# HISTORIC DISTRICT COMMISSION ADDITIONAL INFORMATION REQUEST

**Application Number:** HDC2026-00199

<b>NAME:</b> Logan R Autrey		<b>COMPANY NAME:</b> New Hue Restoration + Design, LLC	
<b>ADDRESS:</b> 568 Terrace Lane North	<b>CITY:</b> Ypsilanti	<b>STATE:</b> MI	<b>ZIP:</b> 48198
<b>PROJECT ADDRESS:</b> 2204 Seminole st.			
<b>HISTORIC DISTRICT:</b> Indian Village

## Third Floor Renovation HDC Application

East Facing Dormer(backyard)

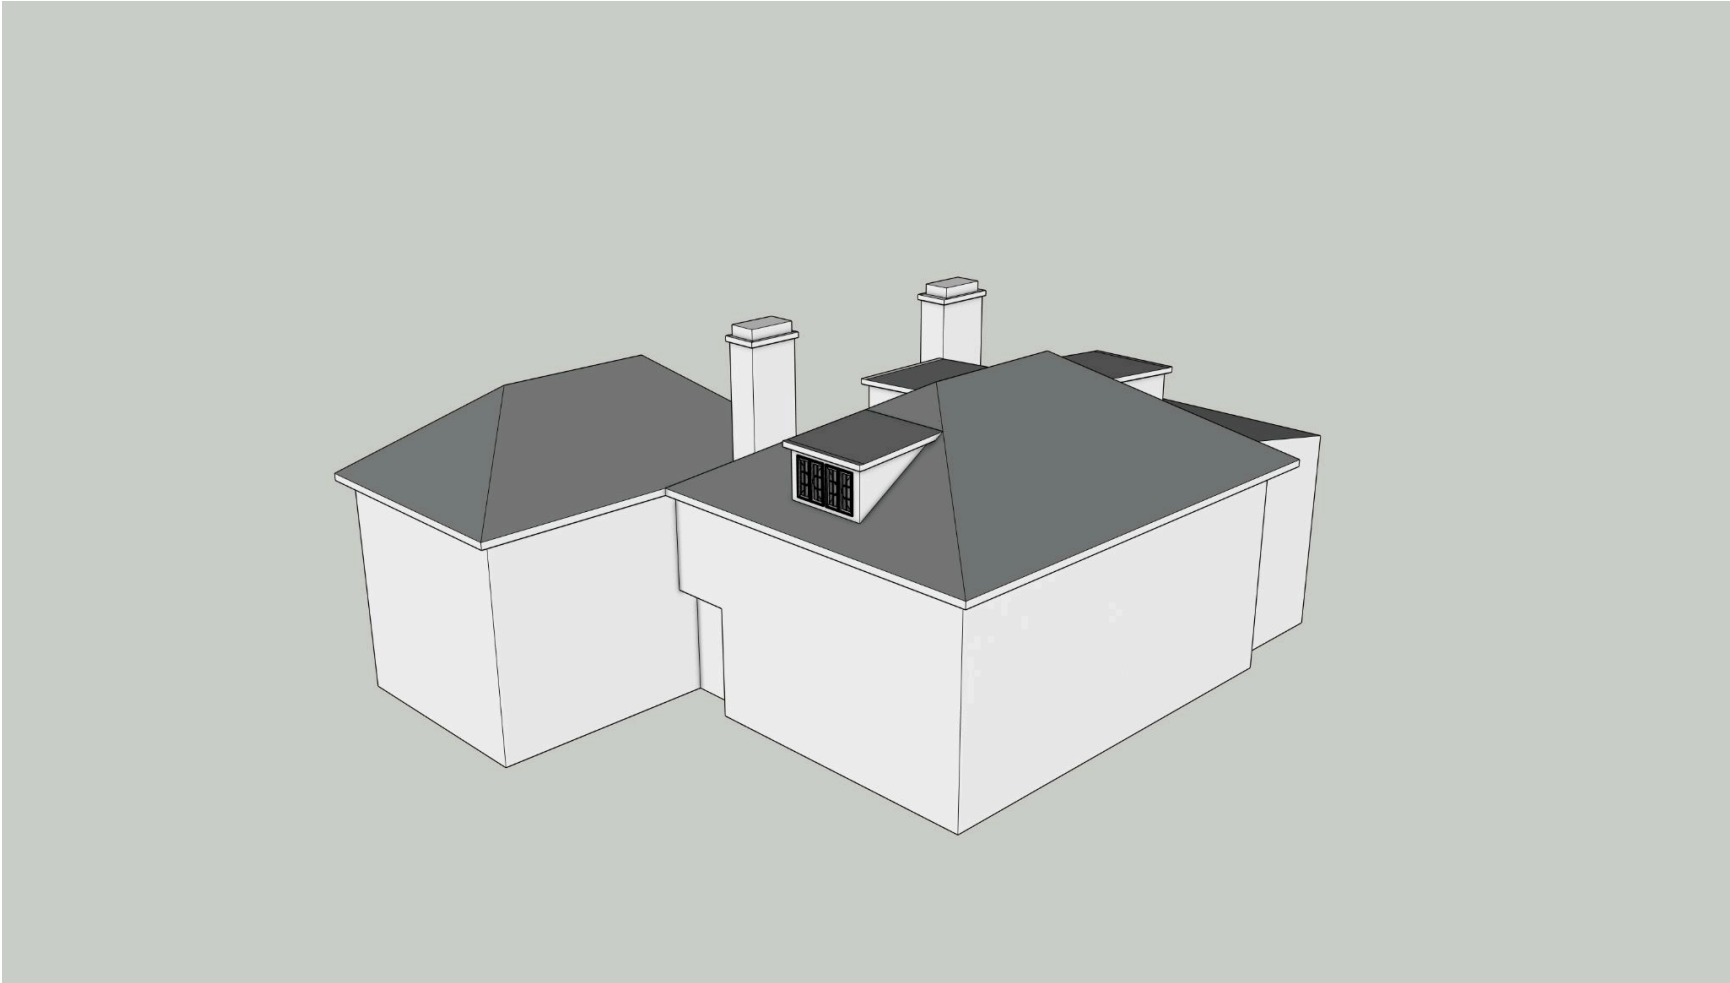
- Exterior photos of the existing dormers, labeled (I see one dormer photographed from the backyard--the east elevation I believe--but it is too dark to see materials on it.)

**Existing Window/Dormer Conditions:** All three dormers are clad with basic square stock trim and vertical shiplap siding. North and south dormers have historic casement style windows. The east dormer has replacement style double hung windows. Exterior carpentry including sashes have deteriorated and need replacing. The wood has dry rotted severely. Crucial to this project is to install new sheathing, framing and vapor barrier - which means the removal of siding and trim.

**Head Jamb and Sill**

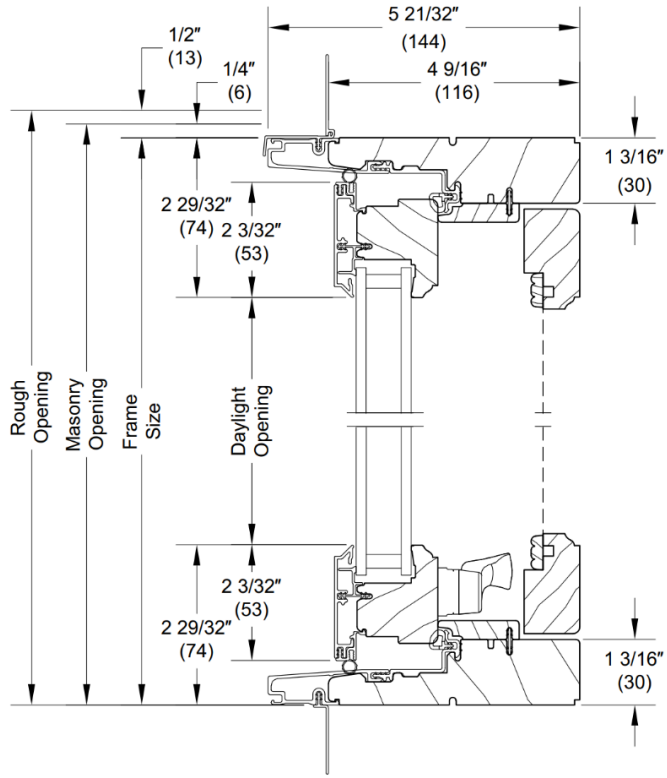
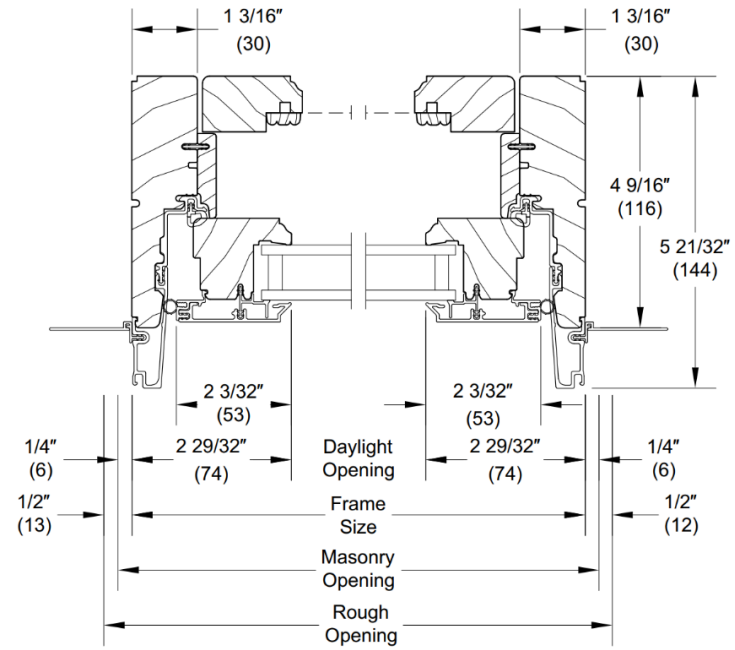
- Please provide window sections for the proposed replacement windows.
- It appears that one pair of casement windows (the south?) is historic and that the existing casements are original. The Secretary of the Interior's Standards for Rehabilitation require that historic material be repaired, and if the material is deteriorated beyond repair, the proposed replacement will match the existing. Please provide more detailed photos showing the condition of those historic windows, and please see the window guide attached.

- Please provide measurements of the historic casement window components and the same measurements for the proposed replacements. A measuring guide for a double-hung window is attached. For casement sashes, please provide the measurements of the two horizontal components (the rails), the measurements for the side vertical components (the stiles), and please provide the measurements and profile of the muntins. These same measurements need to be provided for the proposed replacements, as well. Also needed are existing and proposed trim/casing details (profile and measurements).

Muntin: 7/8" interior and exterior with ogee
